WARRANTY BULLETIN

Campaign no.: 2014-0010

Subject: **A - Fast Flasher Blink Rate**
B - Possible Defective Ignition Key

No. **2014-8**

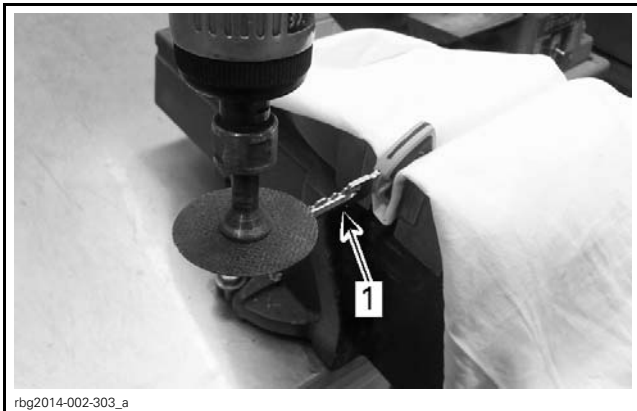
If the VIN is found in *SERIAL NUMBER LIST OF INVOLVED VEHICLES*, and the number on the key tag is found in the *LIST OF AFFECTED KEY TAGS*, carry out the *IGNITION KEY MODIFICATION* procedure. Refer to *PROCEDURE* in this publication.

NOTE: At PDI, the key tag is attached to the key in the glove box. If the key tag is not found, refer to TST Article # 78113 (2014 Key Code Identification) to determine the key tag code.

1. Key held in vise

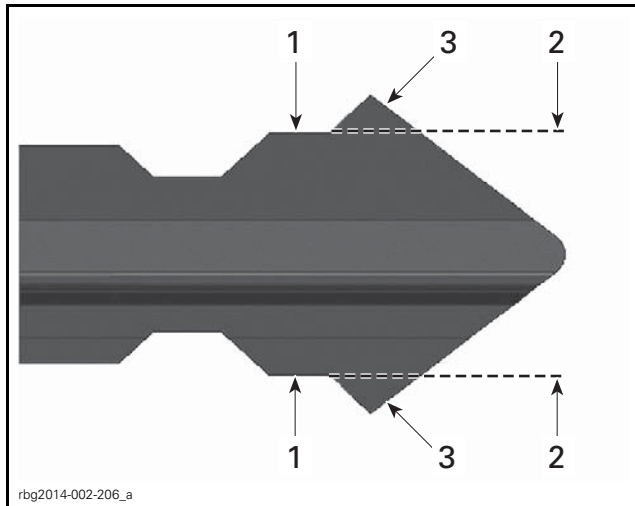
1. Secure ignition key in a vise as illustrated.

NOTE: To prevent vise jaw marks on the key, wrap a clean shop rag around the end of the key to be held in the vise.

NOTICE Do not overly tighten vise or damage to the key will occur.

- rbg2014-002-206_a
1. Reference flat surface
 2. Cut line
 3. Material to remove

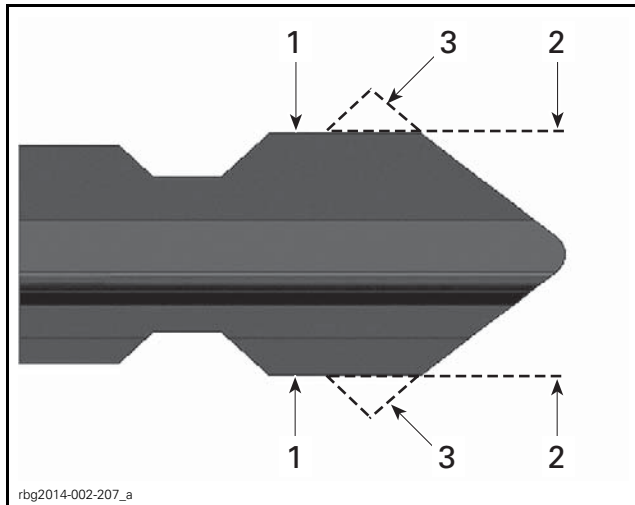
2. Using a small rotary tool, grind off the last point on both sides of the end of the key.

NOTE: The height of the last flat surface will vary with the key code. The modified surface **must be in line with and square** to the last flat surface of the key.
